Subject Title: Amgen Phase 2 (Project Bengal) Development Plan Major Amendment
Meeting Date: January 14, 2025
Presenter: Cheryl Caines, Catherine Jacobs, Development Services
Attachments: Development Plan Application and Plans

Kimley Horn has submitted a request for a Development Plan Major Amendment for approval of the Amgen Phase 2 project located at 4130 Friendship Rd. within the Friendship Innovation Park. The proposal is to construct three (221,903 sq ft) additional buildings for manufacturing, central utility, and manufacturing support/office space.

Motion that the DRC approve Development Plan 21-DP-08-A02 (PLDP202400256) for Amgen Phase 2 Development Plan as submitted by Kimley Horn, dated 12/06/2024, Project # 011175074 with the following conditions:

Planning Comments and Conditions**Cover Page**

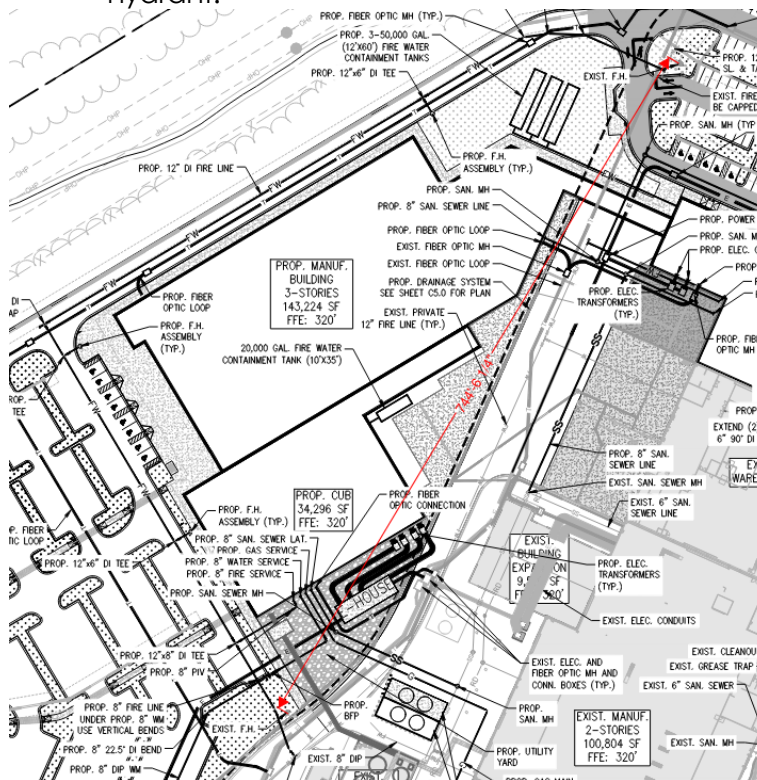
- i. The drive aisle directly adjacent to the Proposed CUB and Utility Yard is greater than 150' and is a dead-end. Please modify this drive aisle to be less than 150' or provide turn around.

4. **Parking Lots (ED&CS Section 3.0)**
 - a. Identify travel lanes for access by emergency vehicles and waste management trucks (minimum pavement cross section 8" ABC and 3" of S9.5B). Show typical pavement cross section for any non-travel lane and note that the minimum cross-section consists of a woven geo-fabric HP 270 or equivalent, 7" ABC, 2.5" I-19, and 3" S9.5C (Section 3.02J).
 - b. Show existing and proposed building dimensions.

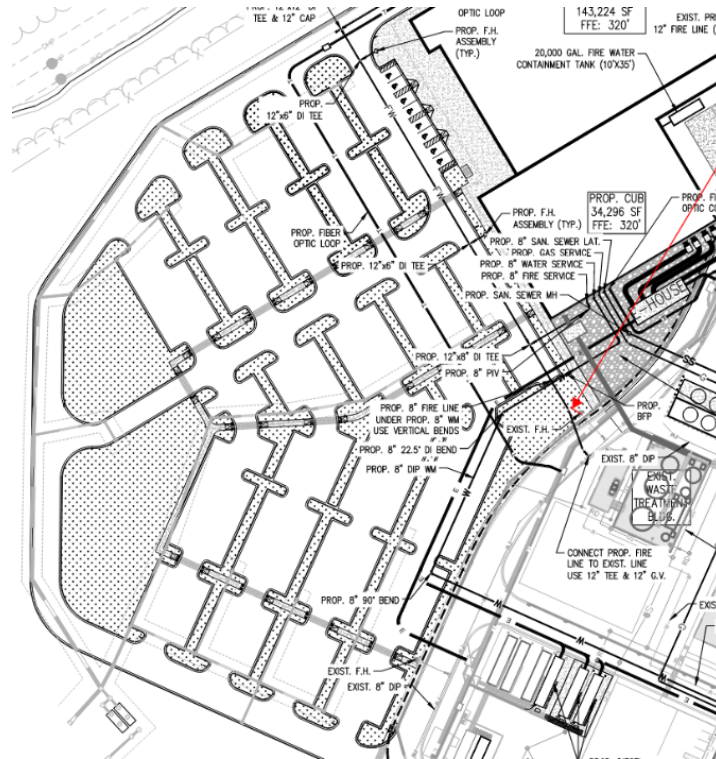
- (1) There does not appear to be a hydrant located along the eastern side of the new buildings. "When a fire access lane is provided then all portions of exterior walls are required to be within 300' of a hydrant."

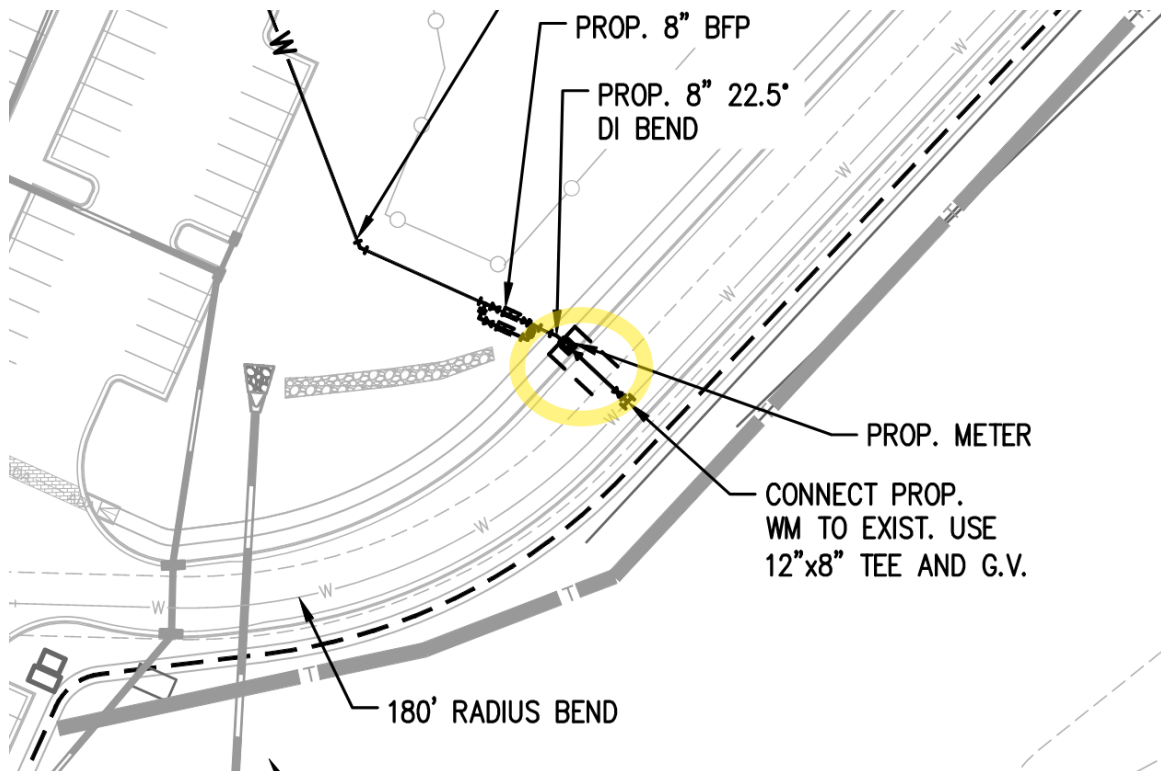
- b. Show sprinkler vaults, Riser Room, Knox Box (Section 6.07).
- c. Fire department connection (FDC) shown within proper spacing from fire hydrant. (Section 6.07). There does not appear to be an FDC for the Manufacturing Building or CUB.
- d. A backflow device is needed for all fire lines – it must be an RPZ type backflow. Please verify this is satisfied with the existing BFP in the existing Pump House.
- e. What is the "type of construction" for each of these buildings? Please provide a written response and refer to E-1 in the ED&CS Section 6.02.E.
- ii. Are there proposed irrigation systems? If so, please show including meters and backflow preventers (Section 6.10).
- iii. Show and label easement widths for all waterlines. New easement shown below but dimensions not labeled.

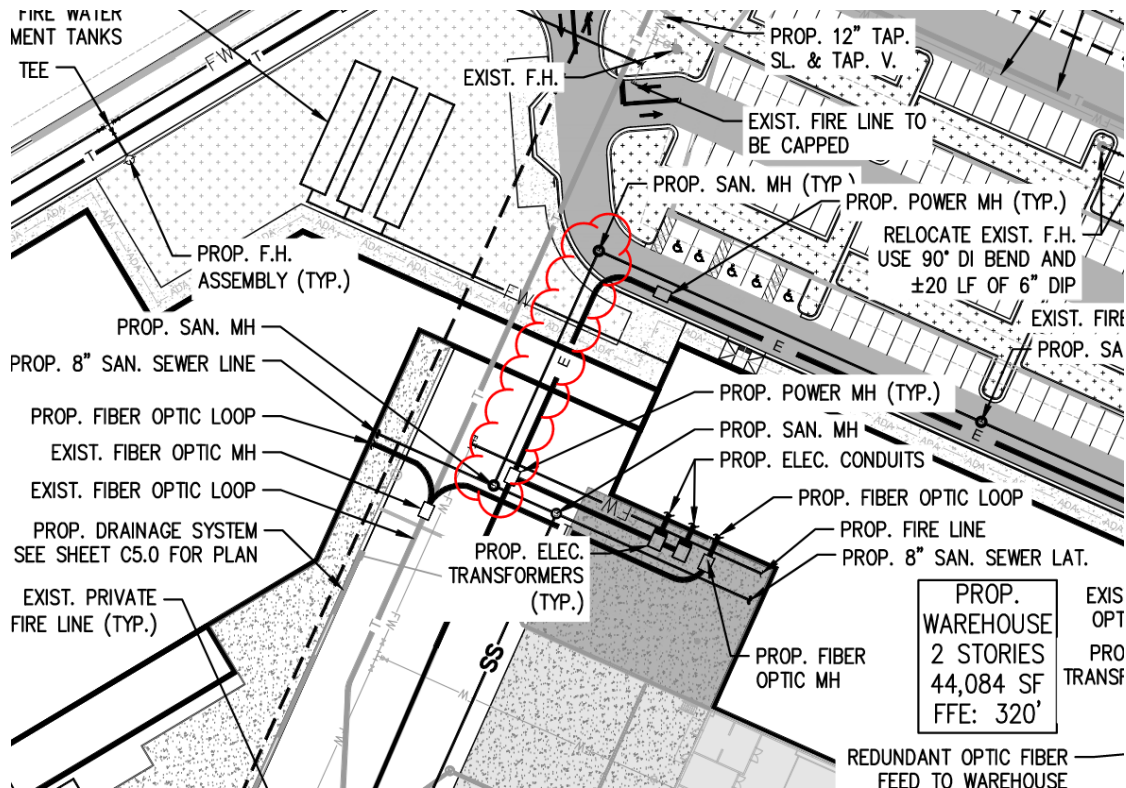
- e. **Onsite sewer layout**
 - i. Verify that the following items are clearly shown and labeled on the plans (including size, material and required easements) – Horizontal design only.

- a. Sewer main material not labeled. Please show on CCD submittal.
 - b. Future maintenance should be considered for sewer main proposed under walkway between Warehouse and Manufacturing Building. Final feasibility will be determined during Construction Drawing review.

f. **Downstream Sewer (ED&CS Section 7.01)**

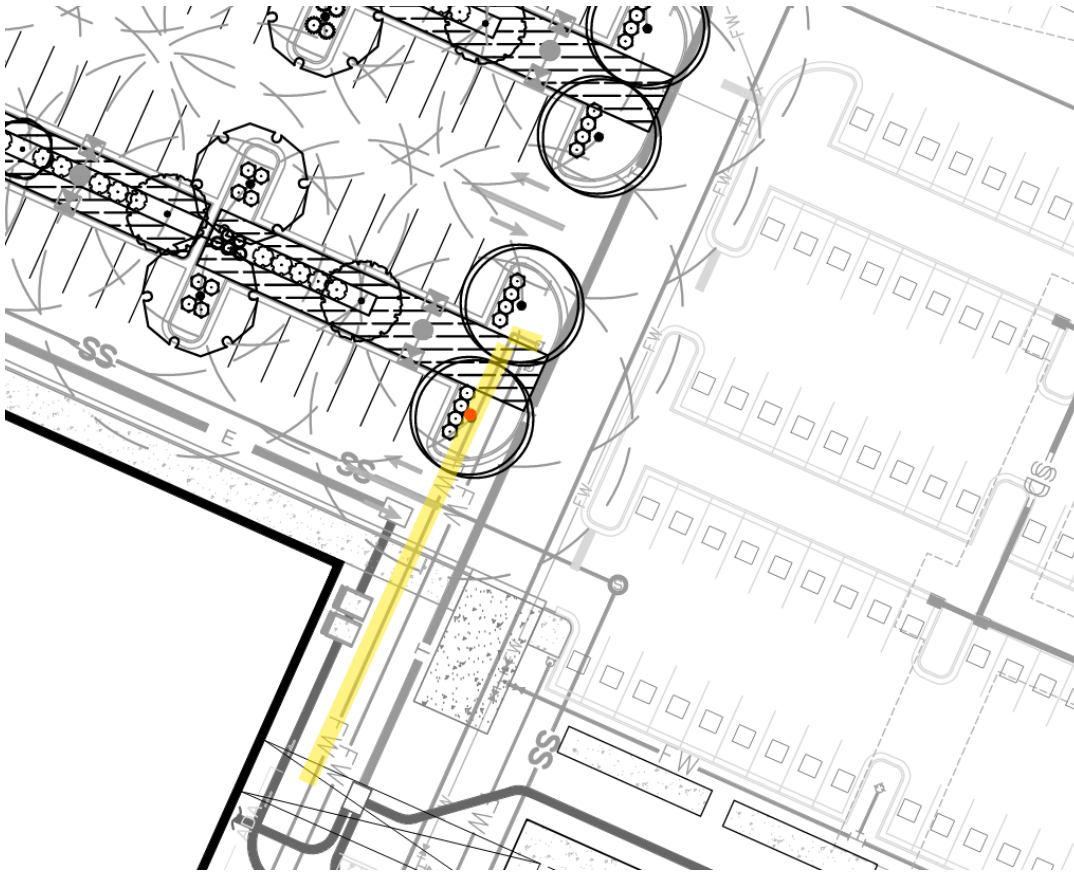
- i. Sanitary Sewer Study – A sewer verification memo is required with this development plan and should be submitted with the first Construction Drawing application as a separate Special Study application in CityView.
 - a. Once submitted, the report will be reviewed by the Town and third-party review consultant. Review comments will be issued under a separate cover. Please address all review comments in writing and re-submit the comment responses and revised Sewer Study and associated model files so that it continues to track along with the Development Plan/Construction Drawings for approval. This report must be provided with the first Construction Drawing submittal. This report must be finalized prior to Construction Drawing approval.
- g. Grease Trap – please use the Town's grease trap detail showing the sampling vault.
